## Amendment #1:

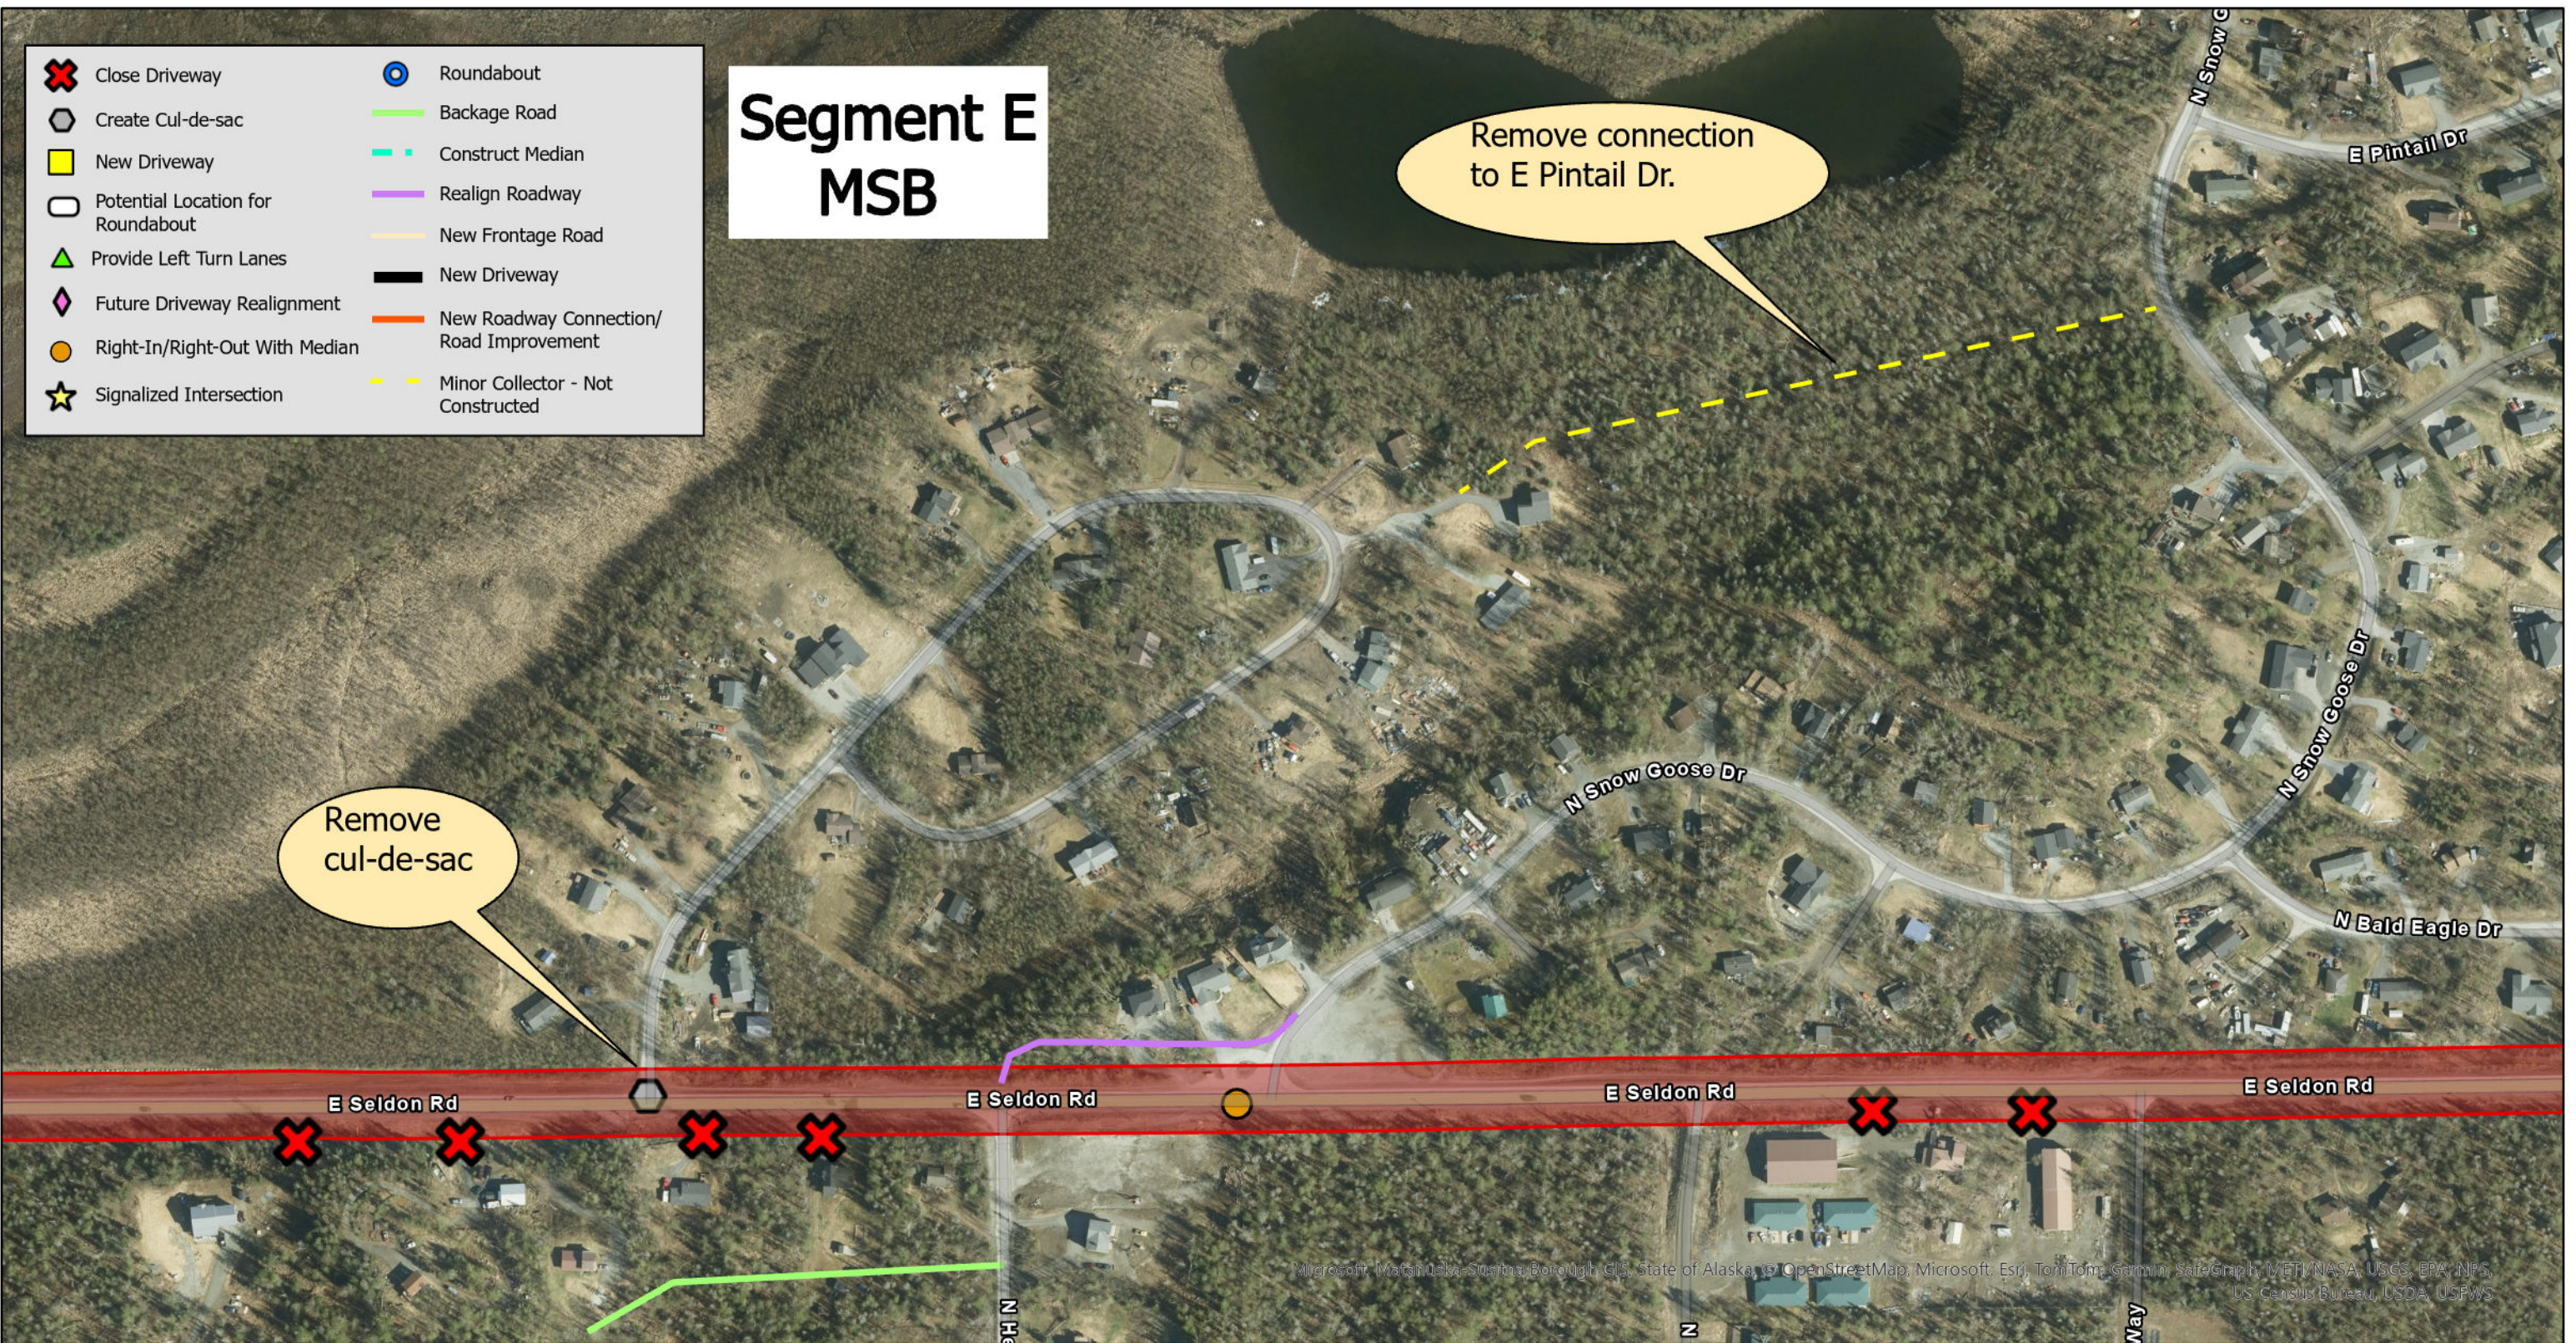
5. Remove the following language from Section 4.6.4.2, pg. 44:

"N Jacksnipe Drive:

o Access to/from Seldon Road is maintained off E Schrock Road."

Remove map symbols (Fig. 7, pg. 47) for cul-de-sac of Jacksnipe Drive

Jacksnipe Dr. is approximately 700 feet from Schrock Road intersection and does not meet recommended intersection spacing.
